Agenda Item	6.1
Report No	PLS-11-24

HIGHLAND COUNCIL

Committee: South Planning Applications Committee
Date: 19 March 2024
Report Title: 23/05217/FUL: Ms Zoe Sheard
Sleat View, Kinloid, Arisaig, PH39 4NS
Report By: Area Planning Manager – South

Description: Erection of house (plot 4) (amended location from previous permission 22/03307/FUL) Retrospective
Ward: 11 – Caol and Mallaig
Development category: Local Development
Reason referred to Committee: Area Manager's discretion.

Drawing:
Site Sections

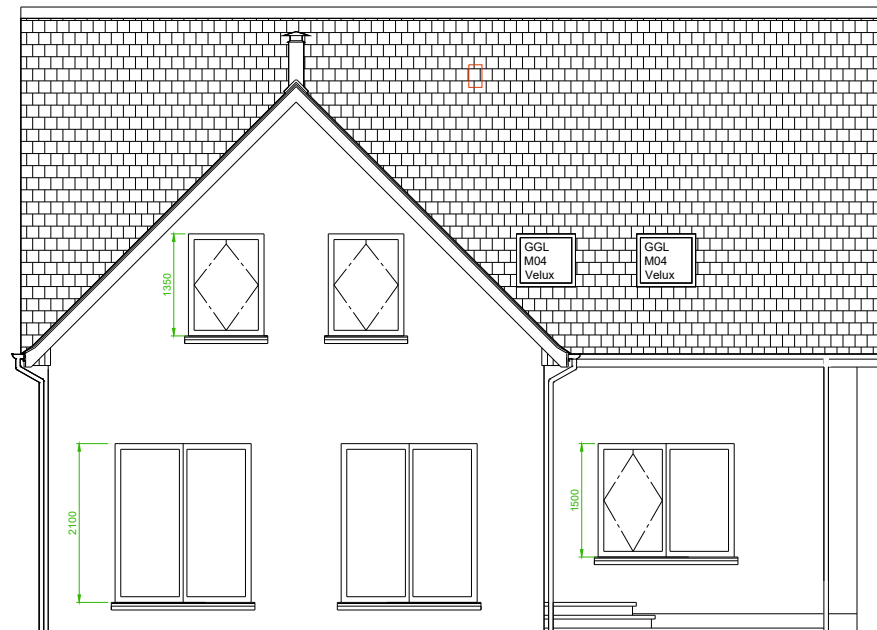
- c) The as-built house level is approx. 1.6m lower than previously approved – the site has been cut to level rather than cut and fill that was proposed. If it had been built as approved it would have had a more drastic impact from the A830, regardless of its position.

Drawing:
Site Location & Layout

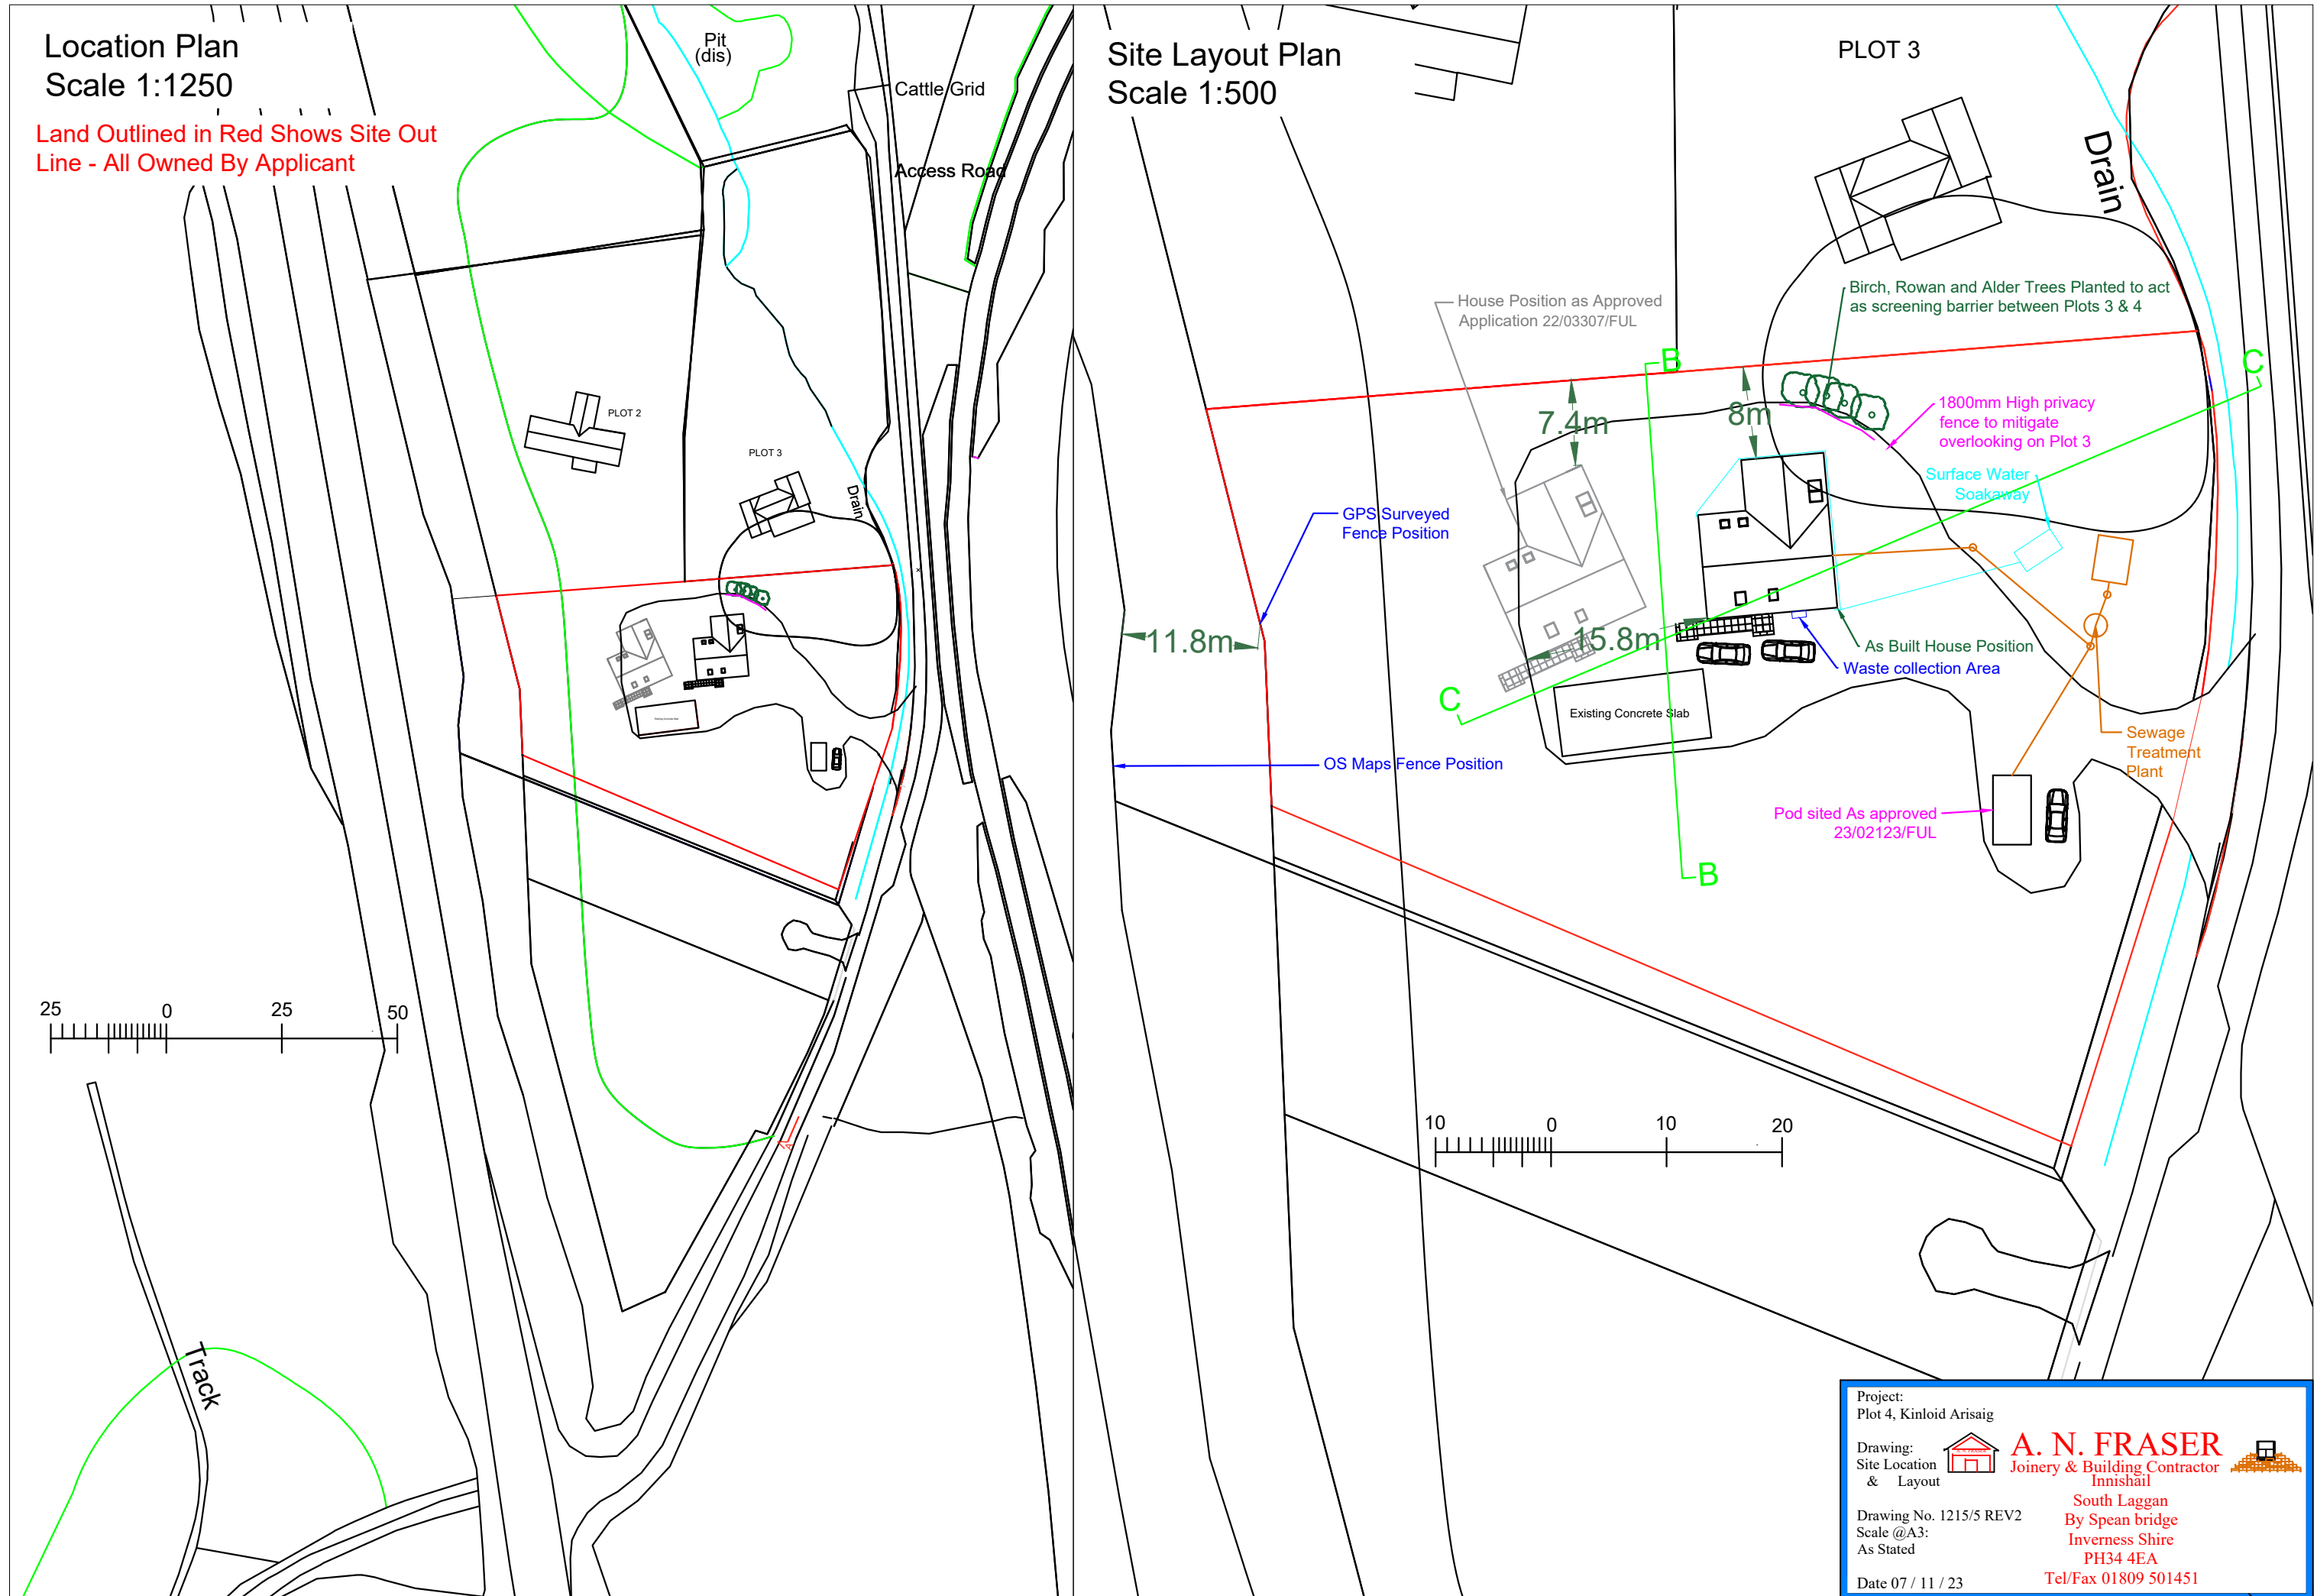
- 1.3 The house, as built, is set 15.8m further to the east within the plot as compared with the approved position. In addition, the footprint has been rotated clockwise by approx. 25 degrees from its NNW position to almost due north. The house is located 8m from the boundary to the north of the plot compared with 7.4m as previously approved. With it being located further to the east the house is now much closer to the approved house position for Plot 3, with a horizontal separation distance between the nearest points of each house of between 15m – 16.75m. This is difficult to measure because of the difference in levels. The driveway and a levelled platform have been created for Plot 3 with the corners of the proposed house marked by stones but construction has not yet commenced. The agent for the applicant for Plot 4 has stated that the amount of cut made to create the level platform for the house as built on Plot 4 was greater than originally proposed, and there was less fill at the front/north side of the plot, and this was undertaken in order to reduce the elevation of the house overall.

- 1.4 There is a marked change in levels at the shared boundary between Plots 4 and 3, the difference in levels being greatest at the NE corner of Plot 4 and the SW corner of Plot 3. The ground has been raised by approx. 0.45m at the front (north east side) of Plot 4 following the construction of the house to create a low screening mound. There is a cut of over 2.5m high at the SW corner of Plot 3, and the unaltered intervening ground slopes steeply from Plot 4 down to Plot 3 (south to north). The revised position of the house on Plot 4 is much closer to the proposed house on Plot 3 and is significantly elevated in relation to Plot 3. The revised orientation of the house on Plot 4 results in the two pairs of patio doors in the living room and the two master bedroom windows above (which are escape windows) more directly overlook the proposed house on Plot 3 compared with the situation that was considered to have been the case with the approved plans. A large

- 8.12 The approved positions of the respective houses would have resulted in a separation distance of approx. 29m. There is now a separation distance of somewhere between 15m – 16.75m between the nearest points of the as-built house on Plot 4 and the approved position of the house on Plot 3. The front elevation of the house on Plot 4 (as-built), and the rear elevation of Plot 3 are not parallel; the as-built house was also rotated to face more directly due north which has turned it more towards the rear of Plot 3, whereas its previous approved orientation was more to the NNW. This, together with it being significantly elevated in relation to Plot 3 exacerbates its impact. The difference in finished floor levels is estimated to be 8m when measured from the supporting information submitted on 10 December 2023 and as stated in the objection.

- 8.16 The 'as-built' development is judged to be unacceptable on the basis that the revised position and orientation has resulted in an unacceptable level of overlooking and overbearing to the detriment of the amenity of the future occupants of the approved house on Plot 3.

- 9.1 The revised, as-built position of the house on Plot 4 is too close to the approved site of the house on Plot 3 at between 15m – 16.75m horizontal separation, and its re-orientation to face almost due north has resulted in it more directly overlooking the neighbouring plot. It is also over-bearing due to its finished floor level being approx. 8m higher than the proposed floor level of the house on Plot 3 in this amended position. It will unacceptably affect the privacy and amenity of the future occupants of the house on Plot 3, and the proposed mitigation measures will not

1. The revised, as-built position of the house on Plot 4 will unacceptably affect the privacy and amenity of the occupants of the approved house on Plot 3, by virtue of its proximity to the approved site of the house on Plot 3 at between 15m – 16.75m horizontal separation, its orientation with the principal elevation facing directly towards the neighbouring plot, and its finished floor level being approx. 8m higher than the proposed floor level of the house on Plot 3 in this revised position. The proposed mitigation measures comprising a 0.45m high bund, a 1.8m high fence and tree planting around the NE corner of the house, together with opaque glazing in the master bedroom windows will not adequately overcome these concerns and would appear incongruous, contrary to Policies 14 and 17 of National
